Access Compliance Report

Public Rights-of-Way

(Curb Ramps)

Intersection ID: 14442	Main Street: N_SHARON_AMITY_RD	Cross Street: CENTRAL_AV	Location: NE
ADA ID: 8160EAFD2FDB	Ramp Type: Perp	Initial Pass/Fail: Fail	Overall Compliance: No
Severity Score: 12.5			
Codes/Mitigation Info/Possible Solution		Field Measurements/Component Compliance

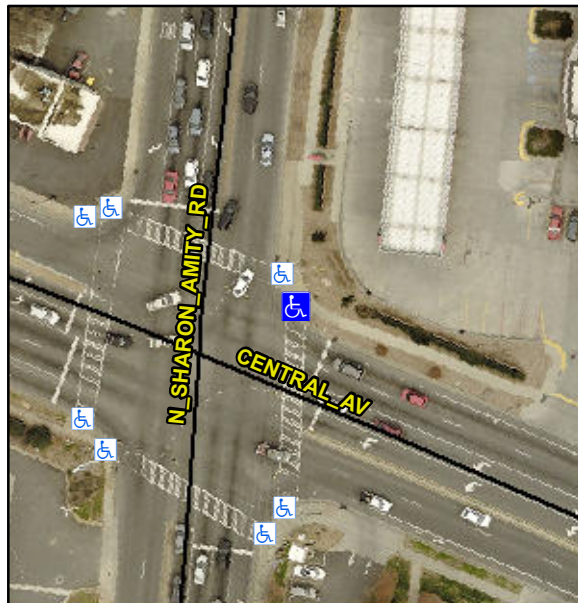
Not Found, R304.2.2

Compliance	Description	Data	Compliance	Description	Data
N/A	Ramp Length (in)	60.5	No	Ramp Slope (%)	10.3
Yes	Ramp Width (in)	48.5	Yes	Ramp XSlope (%)	1.4
N/A	Flare Type LT	N/A	N/A	Flare Type RT	N/A
N/A	Flare Slope LT (%)	N/A	N/A	Flare Slope RT (%)	N/A
N/A	Flare Traversable LT?	N/A	N/A	Flare Traversable RT?	N/A
N/A	Landing Length (in)	N/A	N/A	DWS Provided?	N/A
N/A	Landing Width (in)	N/A	N/A	DWS Contrast?	N/A
N/A	Landing Slope (%)	N/A	N/A	DWS Length (in)	N/A
N/A	Landing X Slope (%)	N/A	N/A	DWS Full Width?	N/A
N/A	Landing Curb? (Y/N)	N/A	N/A	DWS Offset (in)	N/A
N/A	Shared Landing?	N/A			
N/A	Gutter Ponding?	N/A	N/A	Gutter Slope (%)	N/A
N/A	Gutter Lip Ht (in)	N/A	N/A	Gutter X Slope (%)	N/A
N/A	Painted X Walk1?	Yes	N/A	Painted X Walk2?	N/A
	X Walk 1 Direction	To S		X Walk 2 Direction	N/A
N/A	X Walk 1 Width (in)	105.5	N/A	X Walk 2 Width (in)	N/A
	X Walk 1 Slope (%)	6.1		X Walk 2 Slope (%)	N/A
	X Walk 1 X Slope (%)	0.7		X Walk 2 X Slope (%)	N/A

Remove & Replace Entire Ramp.
